CHANGE OF USE OF EX-BELL PUBLIC HOUSE TO A SHOP (CLASS E) INCLUDING PART DEMOLITION, SINGLE STOREY REAR EXTENSION & EXTERNAL WORKS

**THE BELL INN, 33 CHURCH STREET, PINCHBECK, SPALDING, LINCOLNSHIRE, PE11
3UB**

Application No H14-0523-26

Comments on consultation responses

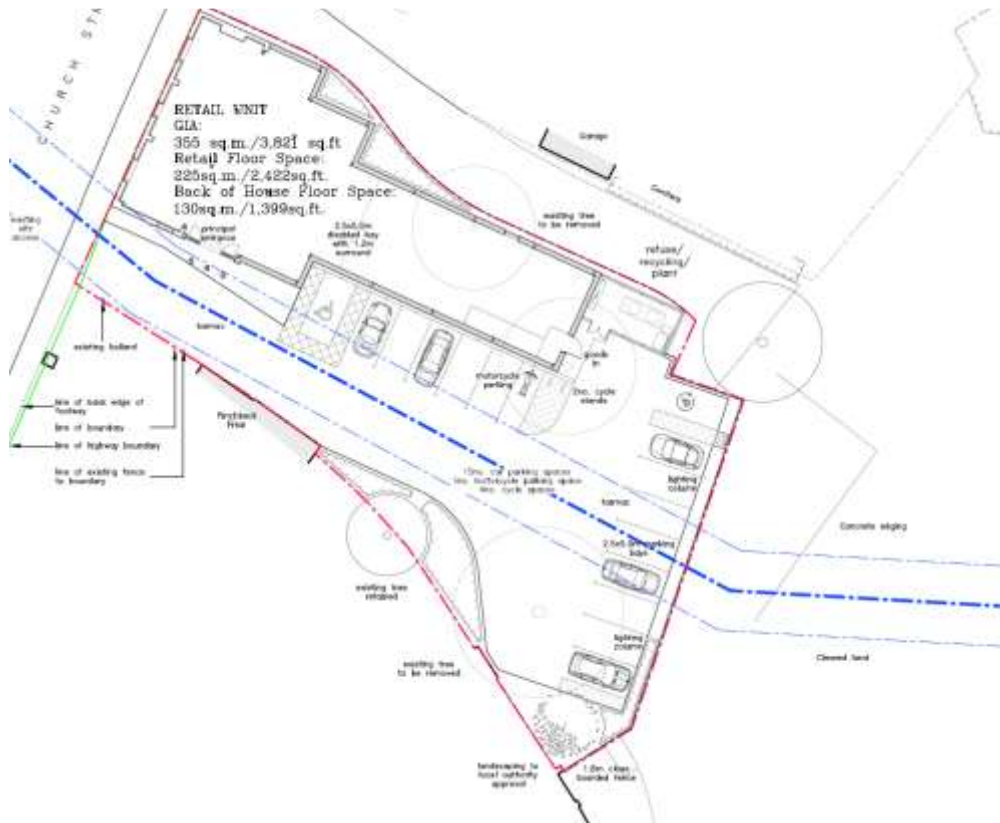
1 ☐ The preliminary roost assessment identified that tree T443 contains two potential roost features; however, no evidence of roosting bats was recorded at the time of survey. The proposed development includes the removal of this tree. Given the recorded bat activity within the area, we recommend that T443 is retained and incorporated as a feature within the car park. This would ensure the retention of two potential bat roosting features on site. BNG Comments and Notes to applicant ☐ Overall, the biodiversity assessment and metric calculations appear rigorous, and we can have confidence in their conclusions. In this case the metric indicates that 10% mandatory net gain cannot be achieved on-site, and therefore the proposals require 1.14 area-habitat units on-site. These will need to be secured pre-commencement and can be achieved via 2 routes:

☐ If the tree T443 was to be retained as previously mentioned, the only 0.95 units would been to be secured pre-commencement. ☐ The metric indicates that 10% mandatory net gain can be achieved on-site with a predicted overall gain of 221.67% in Habitat units Specific BNG condition request ☐ We will require a biodiversity gain plan and all the appropriate onsite details and a finalized metric to be provided for this application.

The Ecology Officer's comments regarding biodiversity net gain appear to contain contradictory conclusions. They state both that 10% net gain cannot be achieved on-site and that the metric predicts an overall on-site gain of 221.67%. The applicant would welcome clarification of the precise

Retention of T443 has been carefully considered. However, its retention would result in the loss of four parking spaces and the principal turning area, thereby potentially creating the highway and parking concerns identified by the Parish Council and previously raised by the Highway Authority. The layout cannot therefore reasonably accommodate the tree without prejudicing the safe and effective operation of the site. Appropriate ecological compensation will be incorporated into the biodiversity gain arrangements. This should also be weighed against the substantial benefit of securing the viable reuse and long-term retention of the former public house, which is identified as a non-designated heritage asset.

The plans below illustrate the fragmented nature of the existing internal arrangement and the open, level trading accommodation achieved by the proposed scheme.

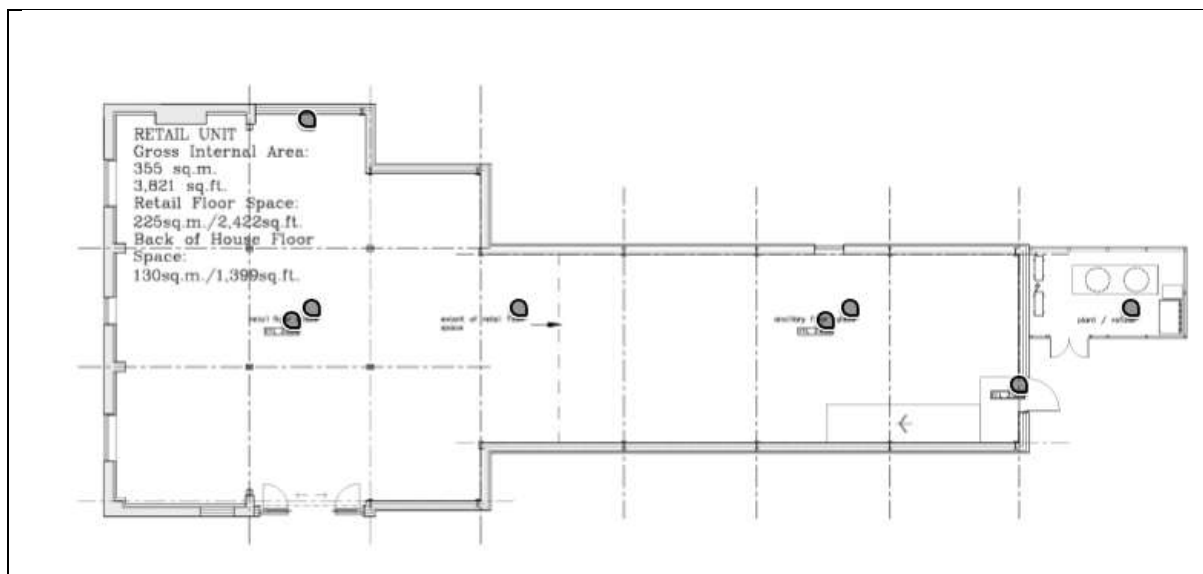
The Conservation Officer expresses concern about the demolition of the rear projection.

The viable reuse of the building cannot be achieved without providing additional, efficient ground-floor trading accommodation. Existing GIA is circa 198m², which makes the assumption that all internal walls could be removed. The necessary GIA for this use is 355m². Even, if the internal walls could be removed the property is 45% too small for the proposed use.. Although the principal part of the former public house can be incorporated into the development, the existing rear projection contains internal structural walls and an upper floor that prevent the creation of the open, level and readily accessible trading area required for the proposed use.

The applicant has considered retaining and extending the rear projection. That option would, however, retain the internal structural constraints, leave the upper floor without a viable use and produce an inefficient and fragmented retail layout. Substantial structural intervention would still be required, while achieving a less satisfactory architectural and operational result.

Removing the rear projection and replacing it with a subordinate single-storey pitched-roof extension would provide the accommodation necessary to secure the building's viable reuse. It would enable the historically and architecturally more important principal range, including its principal elevation, to be retained, repaired and brought back into active use.

Existing and proposed overlay. Floor and ceiling heights shown.

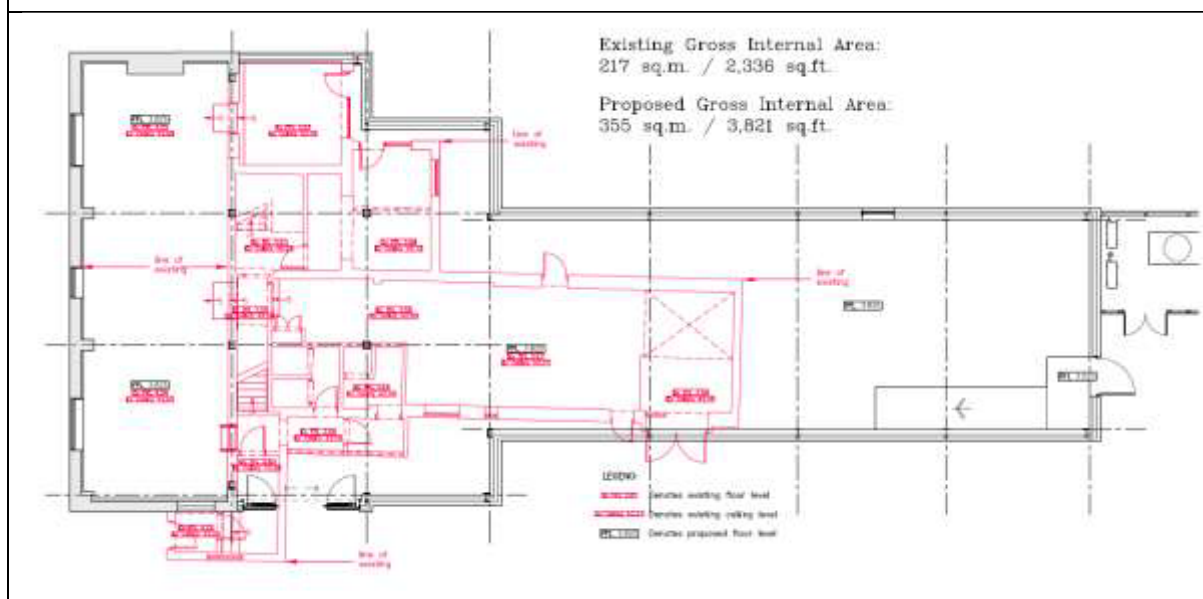
Not only is the floor area insufficient for the proposed retail operation but the many variations in floor and ceiling levels would make the operation of a retail unit an impossibility in many respects, not least disability access.
